Technical Service Bulletin: TSB101061

QST30 Piston Ring Set - Top Compression Ring Change for Service

Figure 1. Profile of New Service Top Compression Piston Ring (left) and Profile of Factory Installed Top Compression Piston Ring and Old Service Top Compression Piston Ring (right).

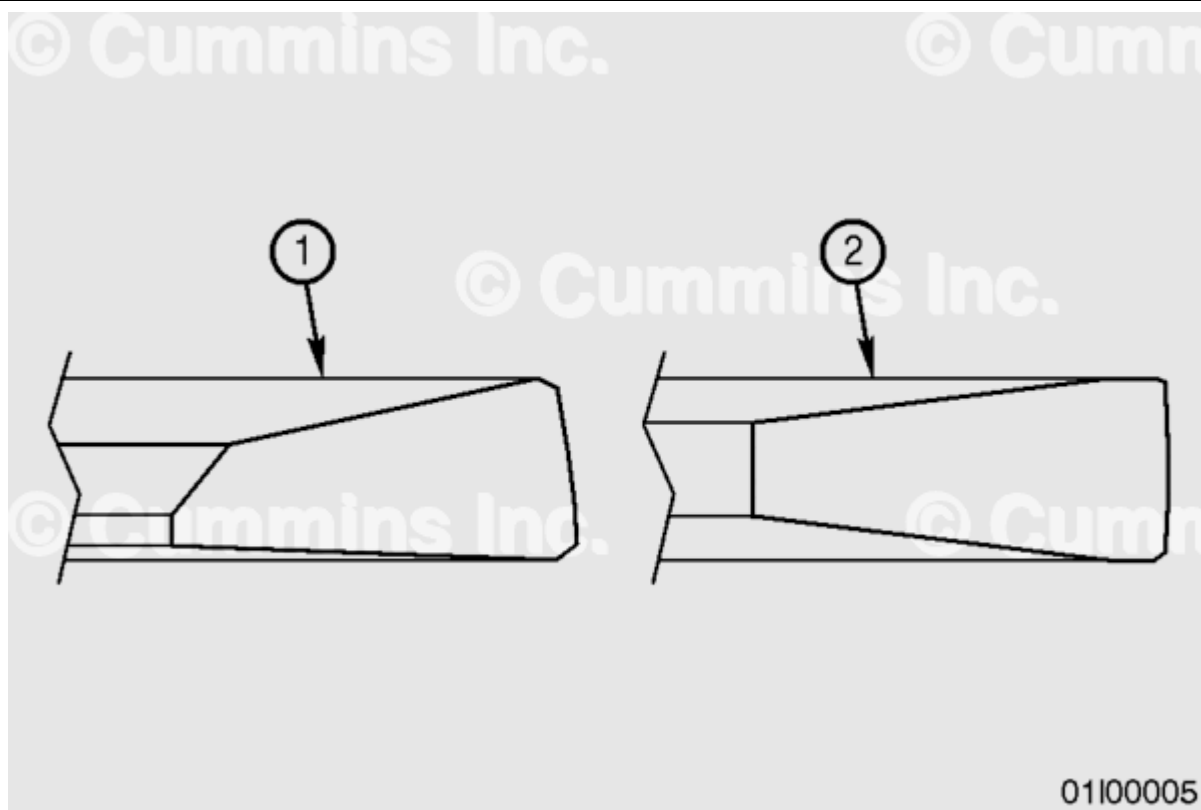
The two different top compression rings are interchangeable, but can be identified by the difference in appearance. The new service top compression piston ring has a white paint mark and the top compression piston ring installed from the factory has an orange color paint mark. The two top compression rings also have different profiles that are shown in Figure 1.

Figure 2. Locations of distinguishing markings on both top compression piston rings.

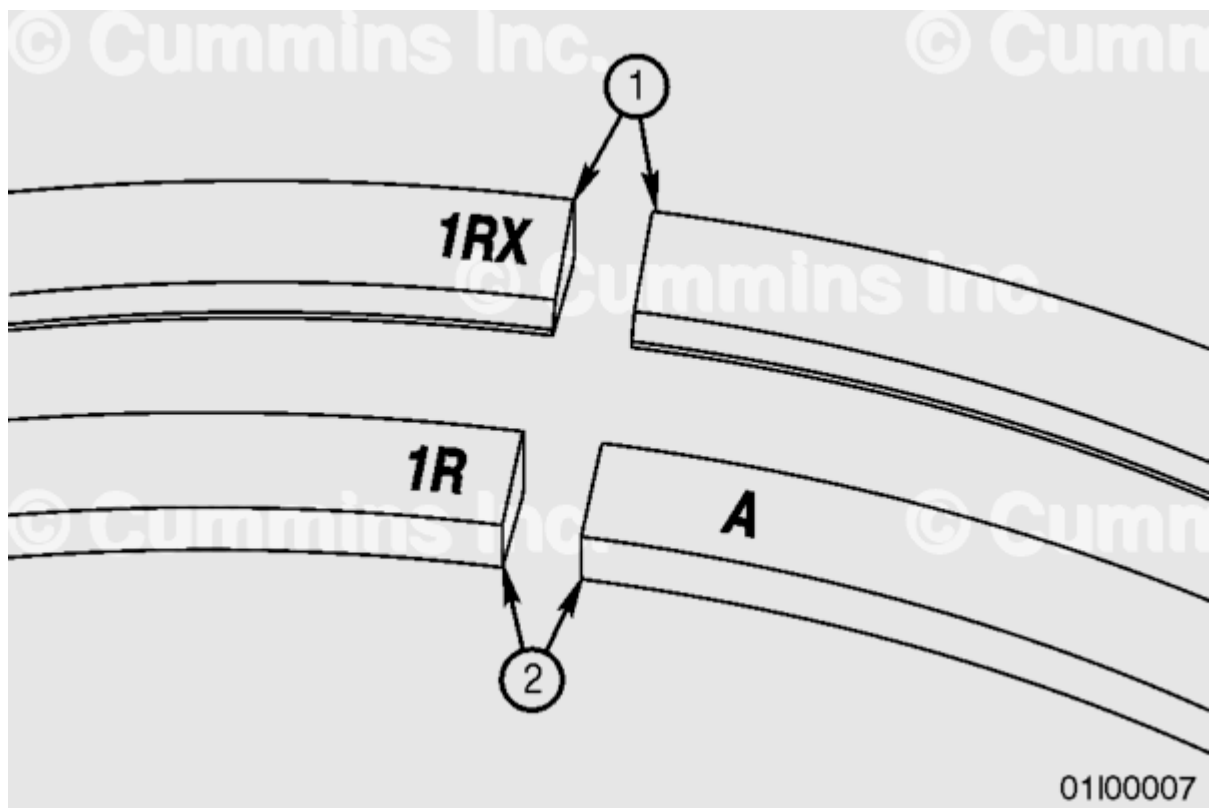
Different markings appear on the two top compression rings. The top compression ring used for service (1) is marked with "1RX" and the top compression piston ring formerly used for service and presently installed in the factory (2) is marked with "1R" on one side of the end gap and "A" on the other side. These markings are shown in Figure 2.

When installing all piston rings, make sure the identification markings are facing up.
